Contract No. T200411209.01
Federal Aid Project No. ESTP-S028(8)
SR 24, Mulberry Knoll to SR 1
Sussex County

Enclosed is Addendum No. 1 for the referenced contract consisting of the following:

Addendum No. 1
October 24, 2019

CS-11
SECTION
AEC
SHEET NO.
60

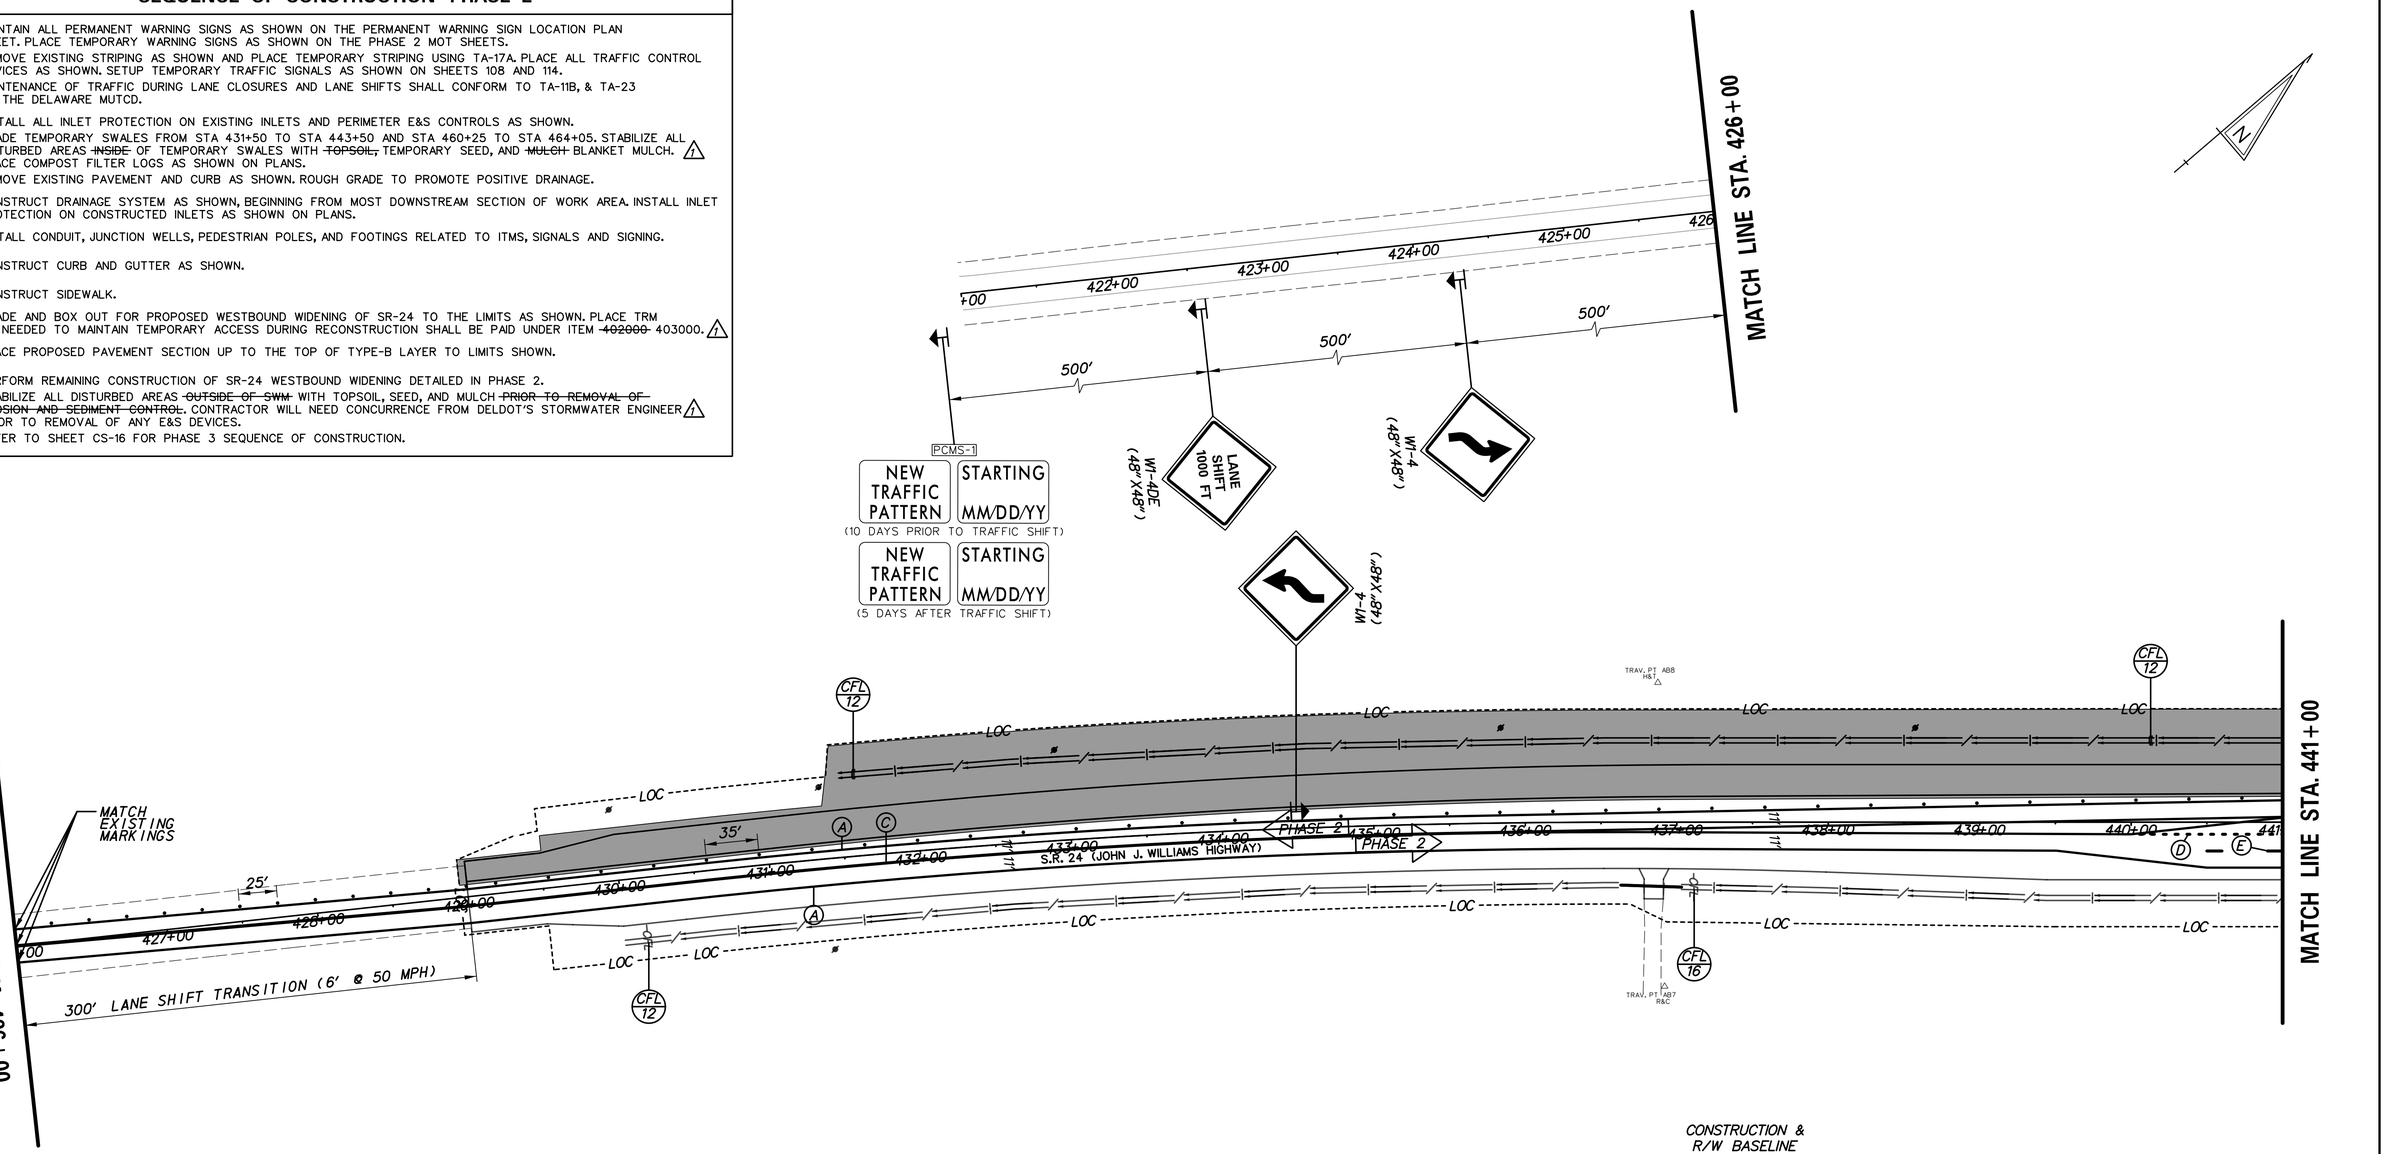
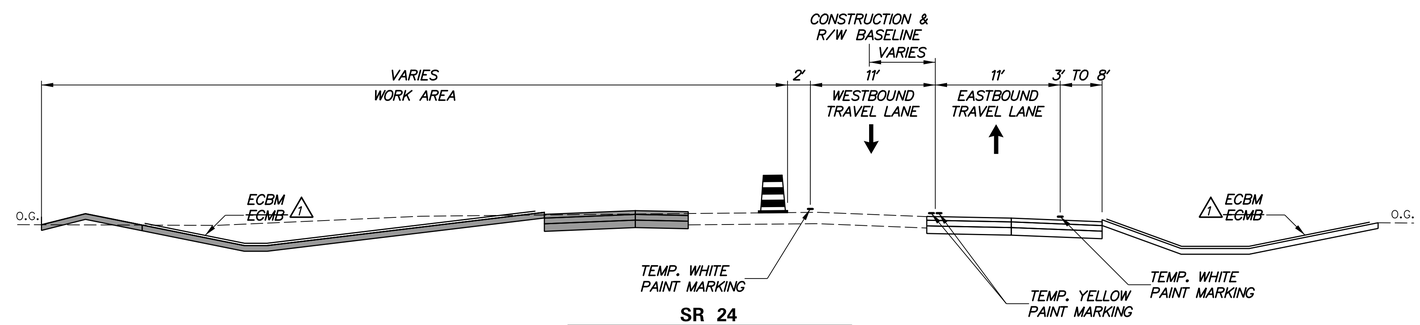
5. GRADE TEMPORARY SWALES FROM STA 431+50 TO STA 443+50 AND STA 460+25 TO STA 464+05. STABILIZE ALL DISTURBED AREAS ~~INSIDE~~ OF TEMPORARY SWALES WITH ~~TOPSOIL,~~ TEMPORARY SEED, AND ~~MULCH~~ BLANKET MULCH. PLACE COMPOST FILTER LOGS AS SHOWN ON PLANS. △1

△1 REVISED SEQUENCE OF CONSTRUCTION	D. SEMPLE 10/03/2019

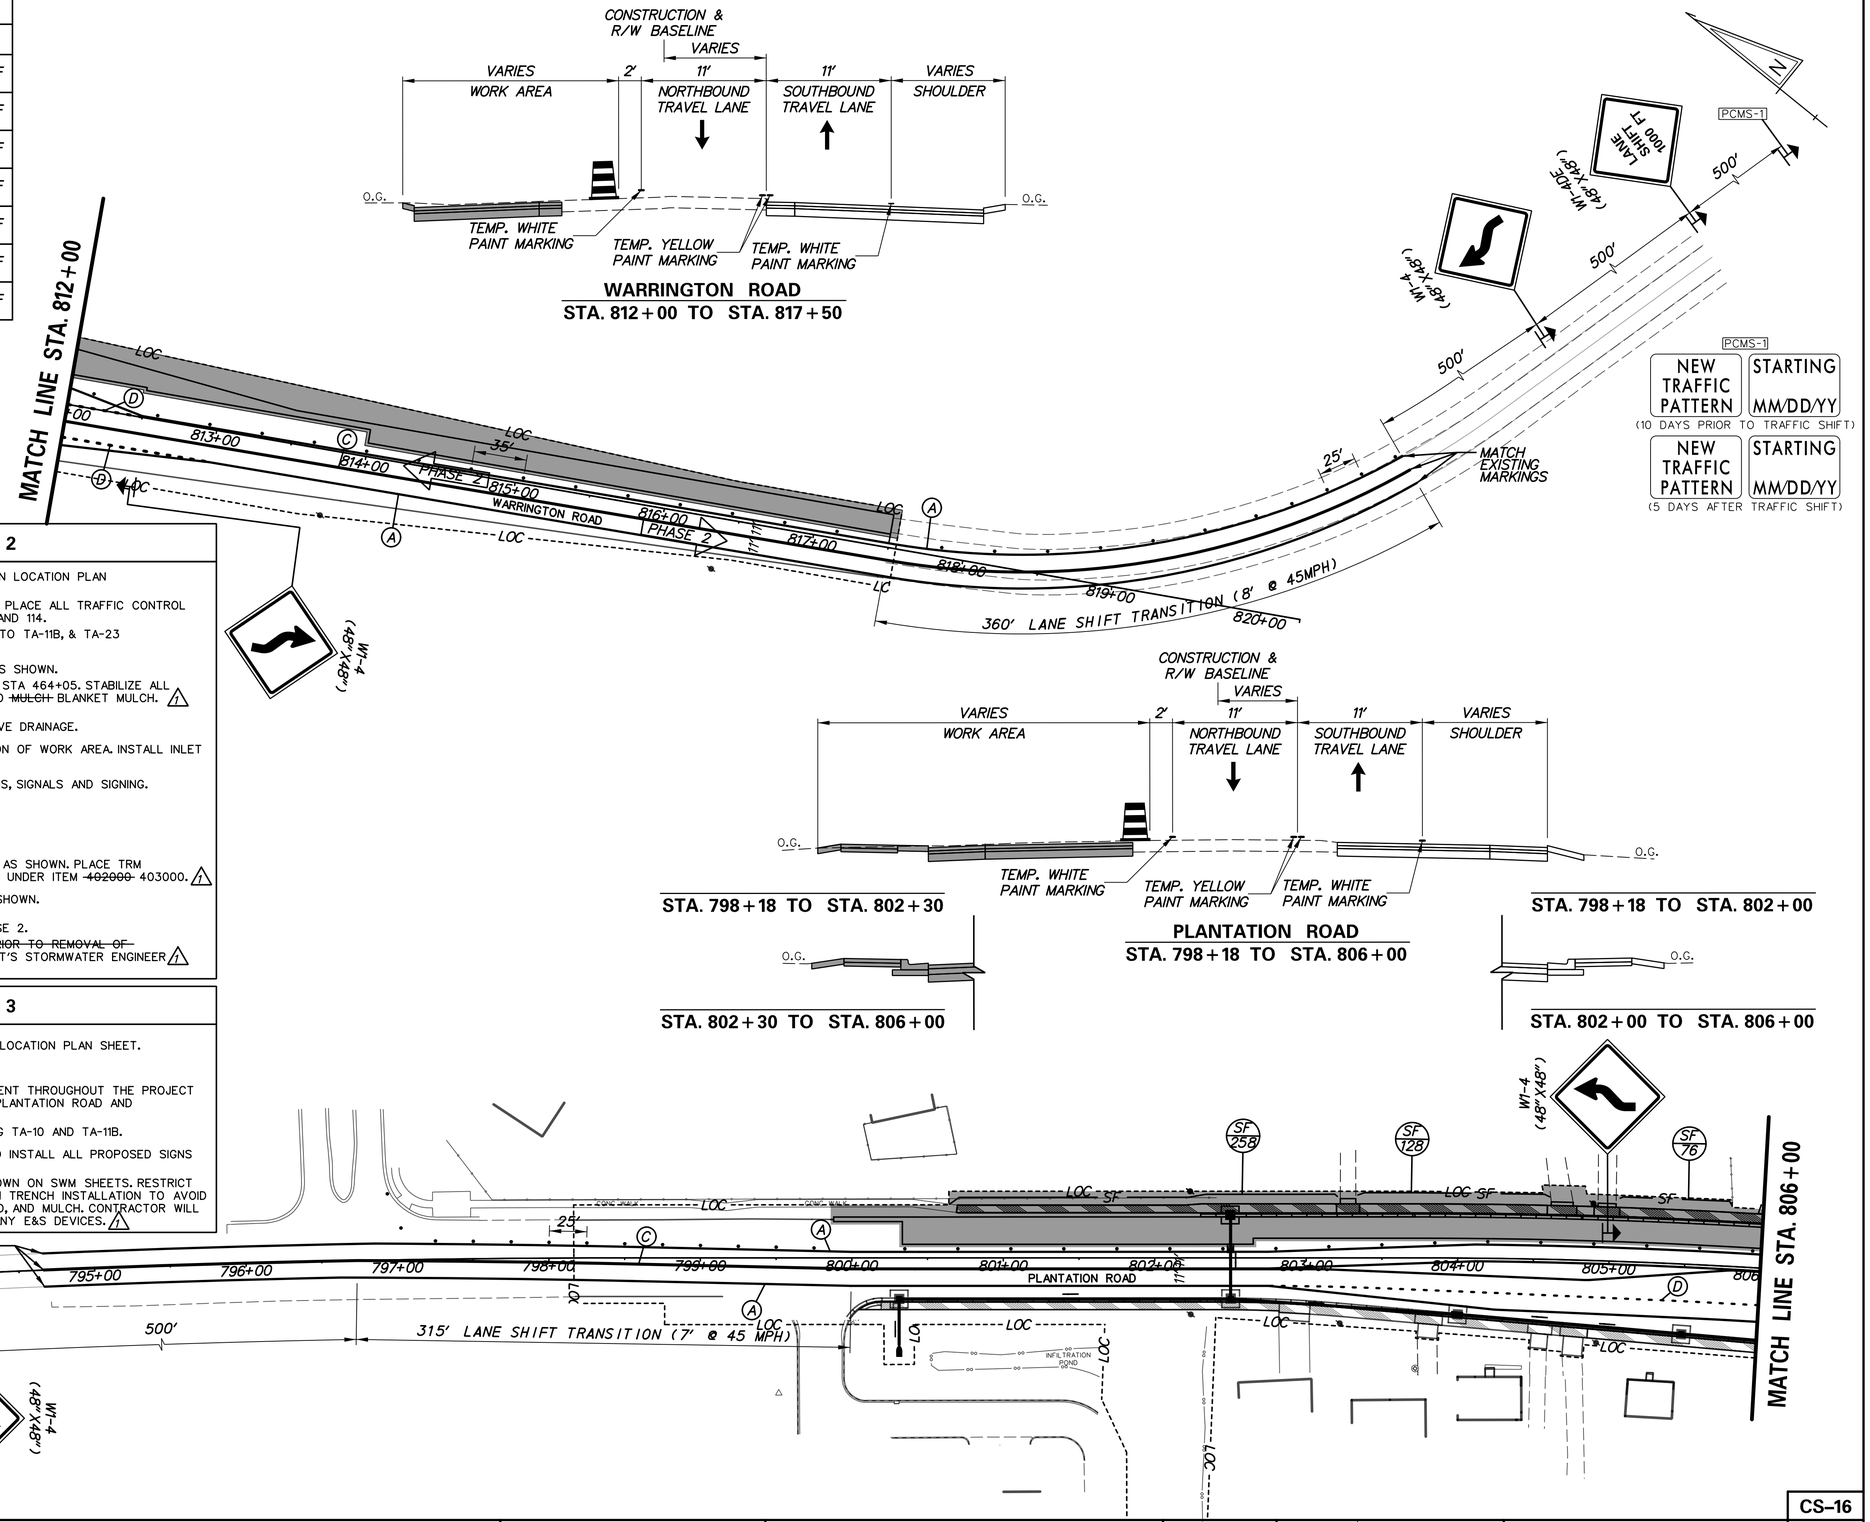
6. FINALIZE CONSTRUCTION OF SWM BMPS BY INSTALLING INFILTRATION TRENCHES AS SHOWN ON SWM SHEETS. RESTRICT EQUIPMENT MOVEMENT OVER THE BMP FLOOR BEFORE, DURING, AND AFTER INFILTRATION TRENCH INSTALLATION TO AVOID OVER-COMPACTION. STABILIZE ALL DISTURBED AREAS AT SWM BMPS WITH TOPSOIL, SEED, AND MULCH. CONTRACTOR WILL NEED CONCURRENCE FROM DELDOT'S STORMWATER ENGINEER PRIOR TO REMOVAL OF ANY E&S DEVICES. 1

ADDENDA / REVISIONS		
1 REVISED SEQUENCE OF CONSTRUCTION	D. SEMPLE 10/03/2019

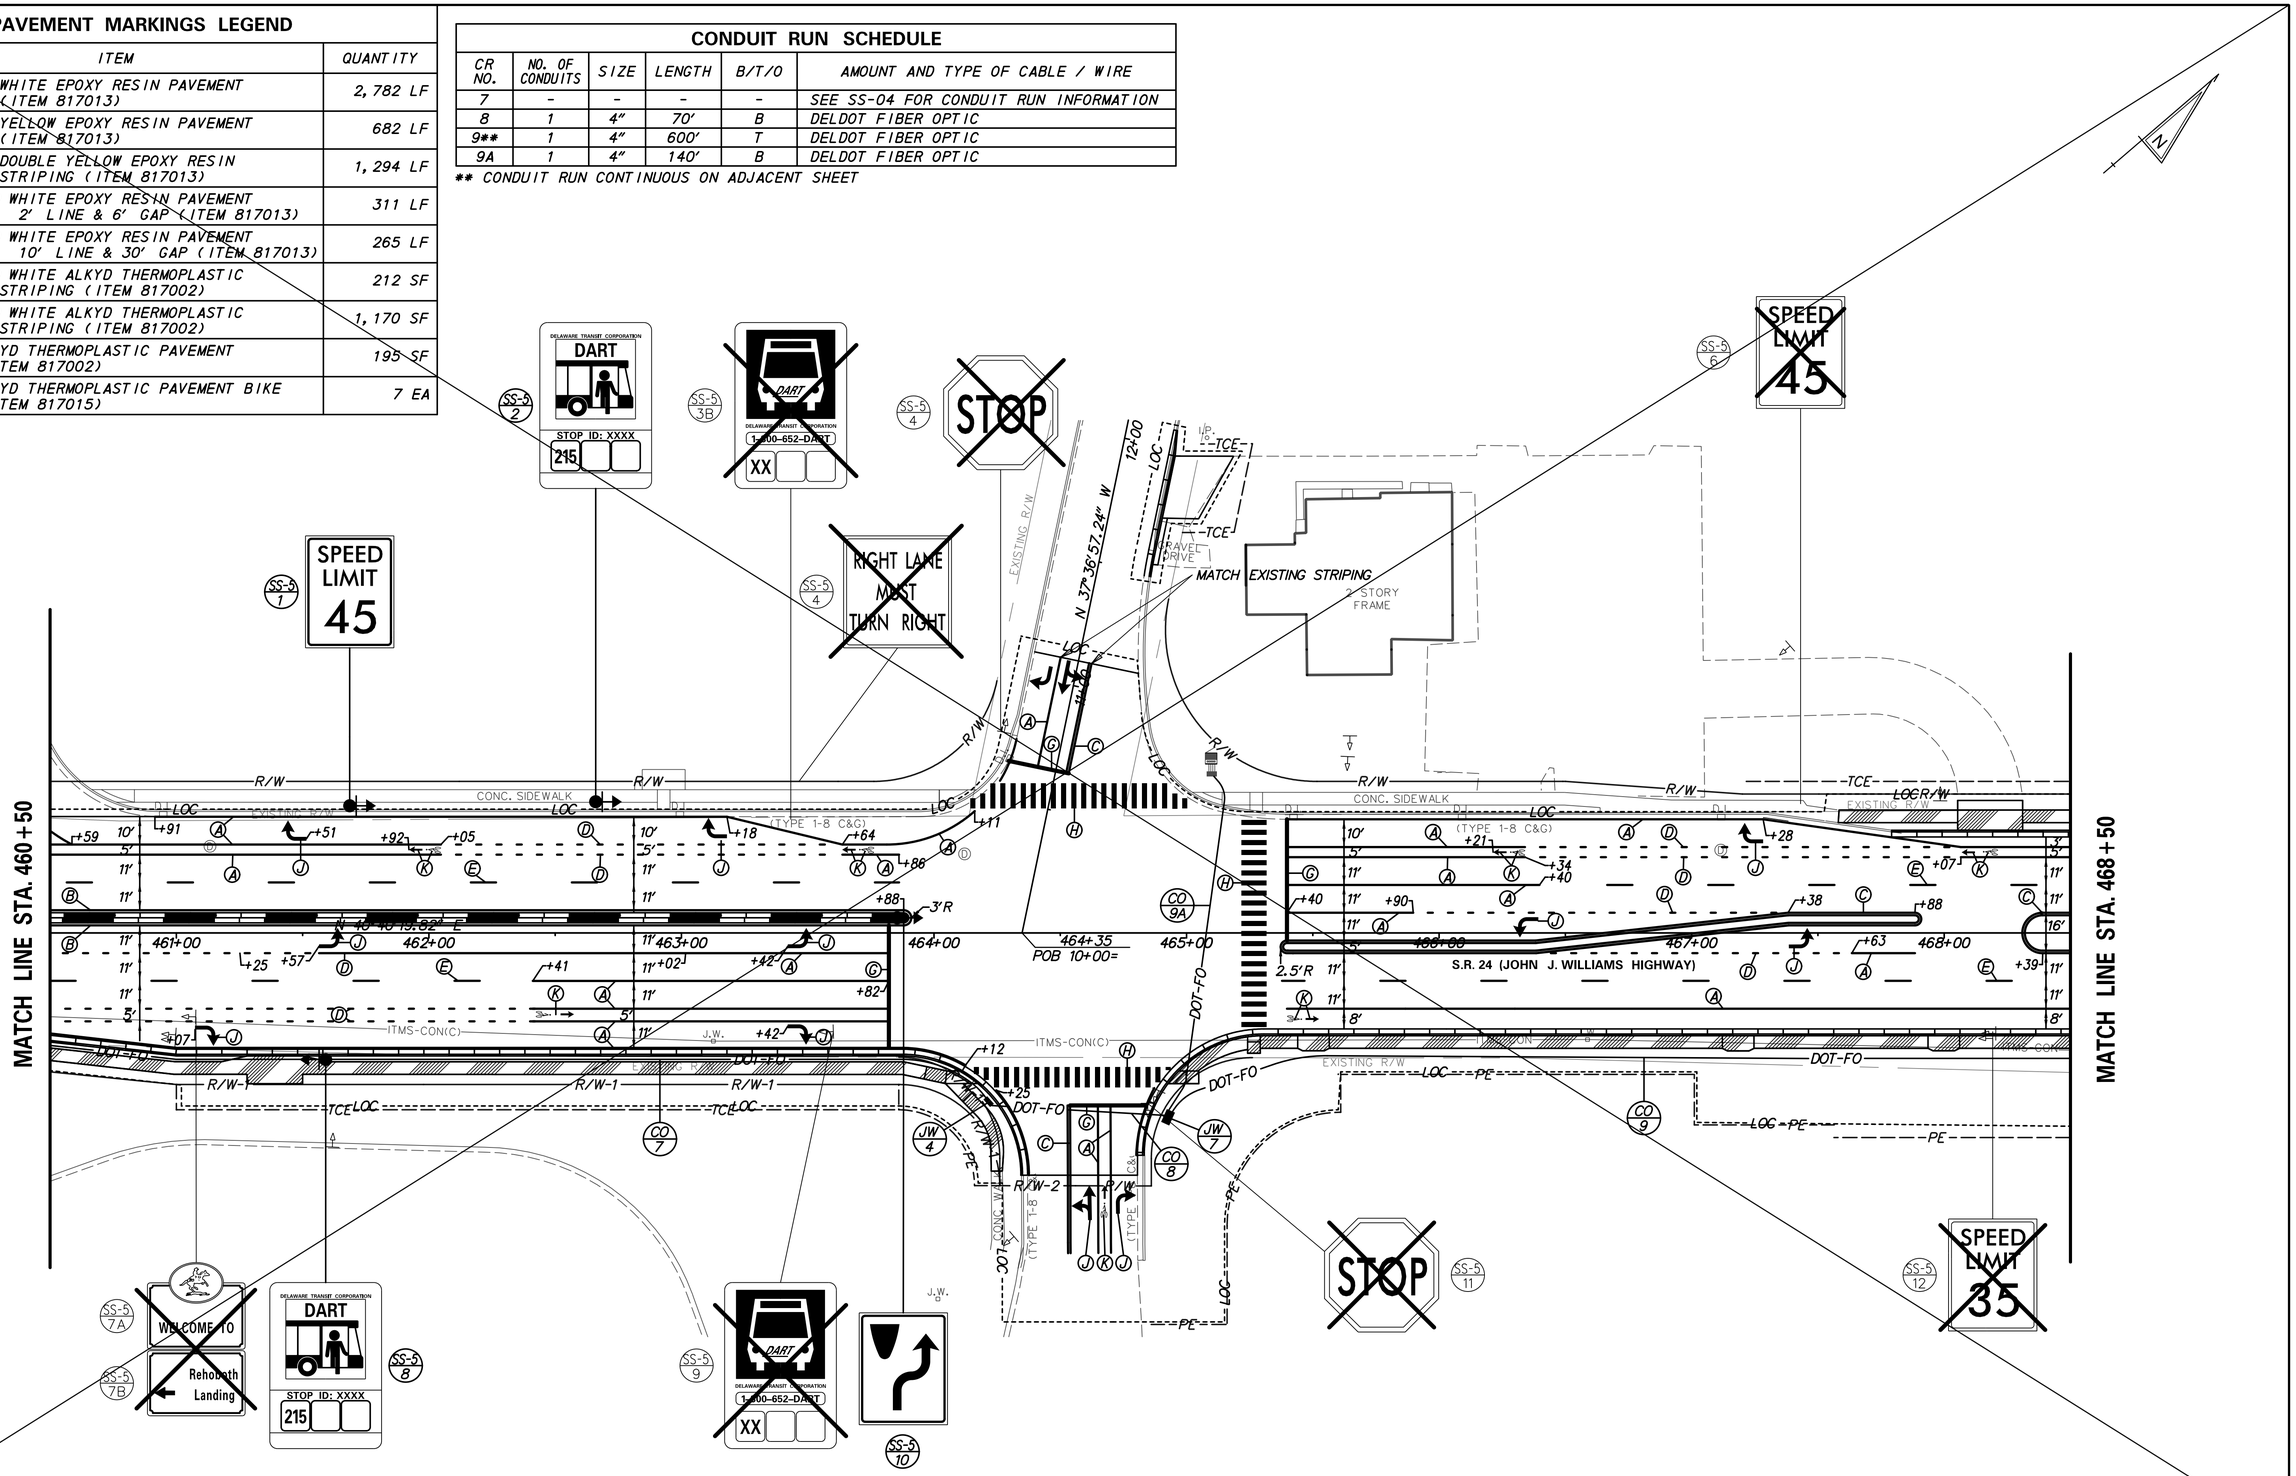
ADDENDA / REVISIONS		
1 REVISED DRIVEWAY LAYOUTS	D. SEMPLE 10/03/2019
